Product Change Notice

Issue Date: 06-April-2021

Change of manufacturer location, change of product packing

AFBR-S4N66C013

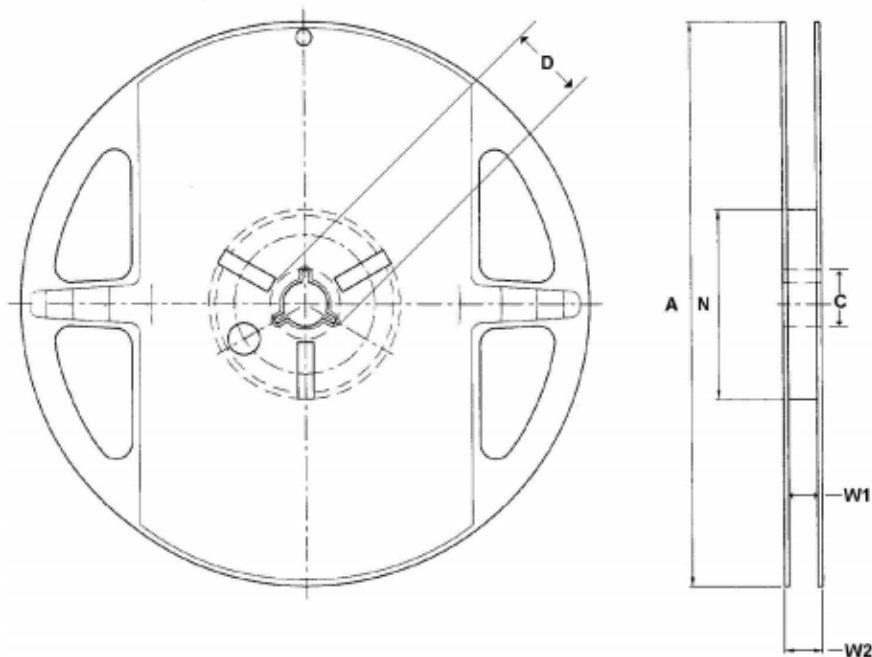
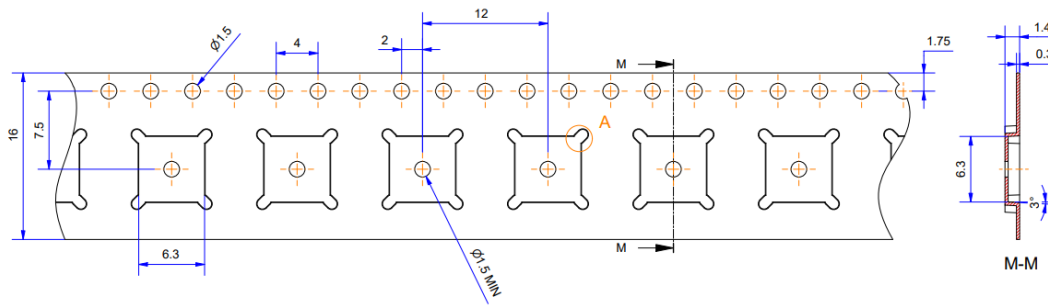
1. Activate additional manufacturing location.
2. Change product packing from waffle packing to reel packing:

Dimensions For Assembled EcoReel (All dimensions in mm)						
Tape Width	A (Diameter)	C	D (min)	N Hub	W1	W2 (max)
16	178 +/-1.0	13.5 +/-0.5	20.2	60 +0.1/-0.0	17 +/-0.5	19.5
All Other Dimensions and Tolerances are Fully Compliant With EIA 481-E

Each tape and reel contains 200 units.

AFBR-S4N44C013

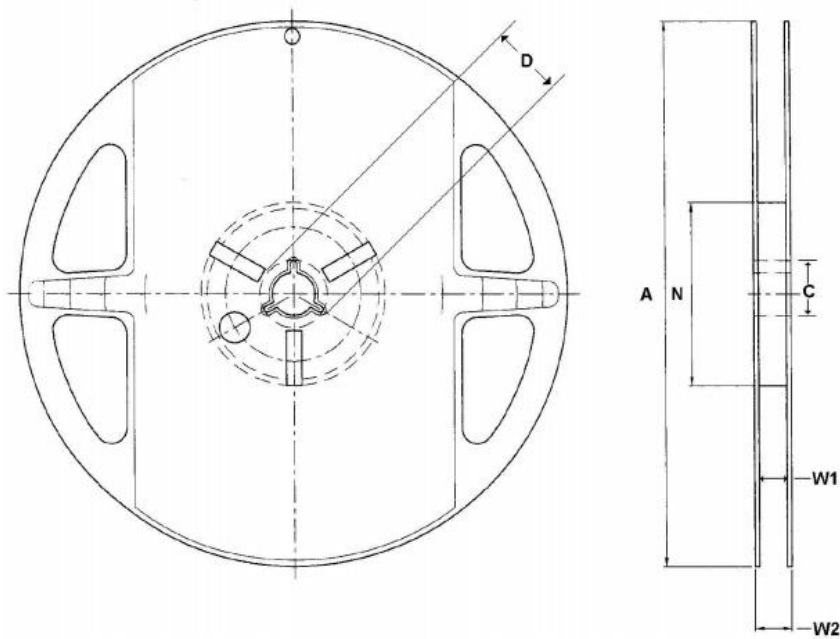
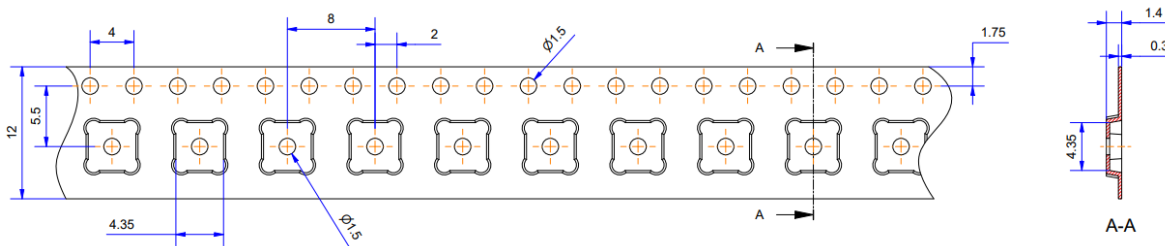
Dimensions For Assembled EcoReel (All dimensions in mm)						
Tape Width	A (Diameter)	C	D (min)	N Hub	W1	W2 (max)
12	178 +/-1.0	13.5 +/-0.5	20.2	60 +0.1/-0.0	13 +/-0.5	15.5
All Other Dimensions and Tolerances are Fully Compliant With EIA 481-E

Each tape and reel contains 500 units.
